SEWAGE DISPOSAL SYSTEM
HOWARD COUNTY HEALTH DEPARTMENT
BUREAU OF ENVIRONMENTAL HEALTH
410-313-2640

A REPAIR

11710
ROUTE 99

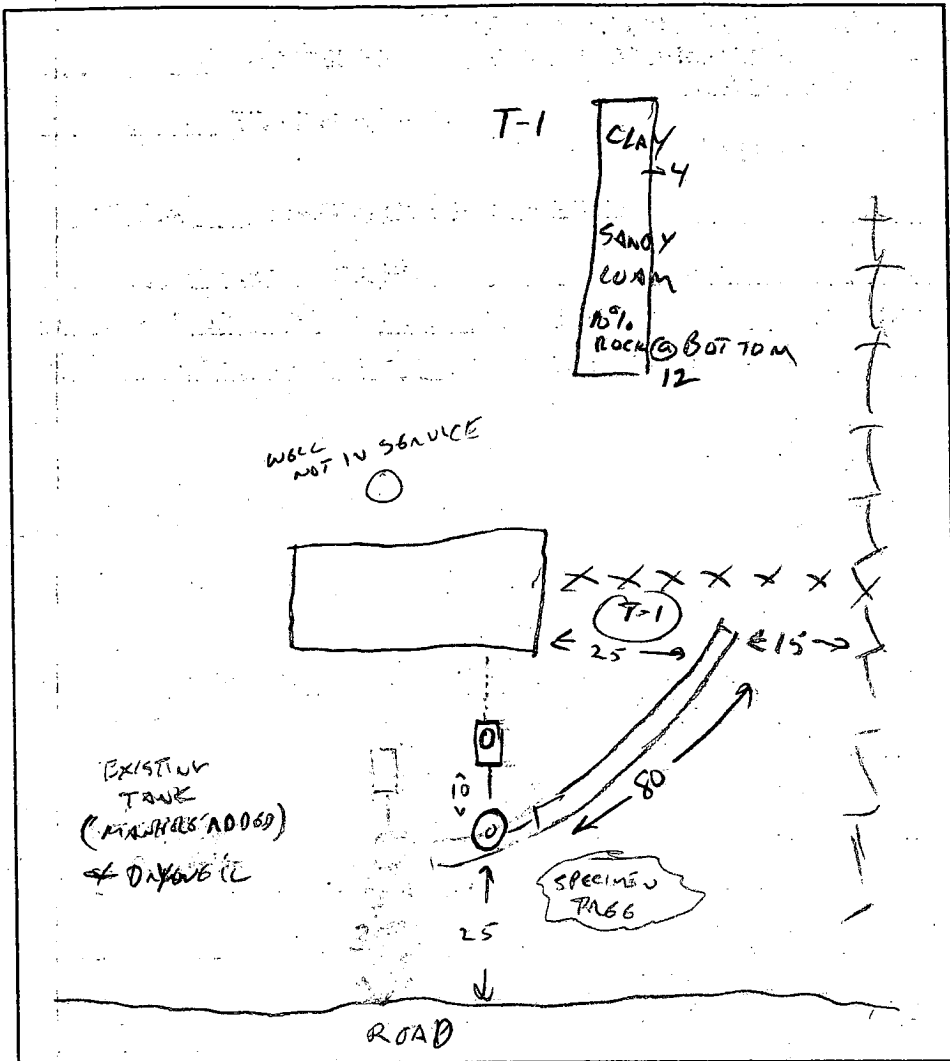
PRE-CONSTRUCTION INSPECTION: LIMITED AREA FOR REPAIR TOWARD STREET.

ADD TAG OFF DRYWELL TOWARD SIDE YARD. 2/22/00 CW

INSPECTION COMMENTS: CONNECTED TO PUBLIC WATER LAST FALL, OWNER CONSIDERING WHETHER TO PROPERLY ABANDON WELL OR PLUMB FOR OUTSIDE SERVICE (FUTURE POOL).

TRENCH COMPLETE, MANHOLE ACCESS ADDED TO SEPTIC TANK, OK TO COVER. 2/24/00 CW
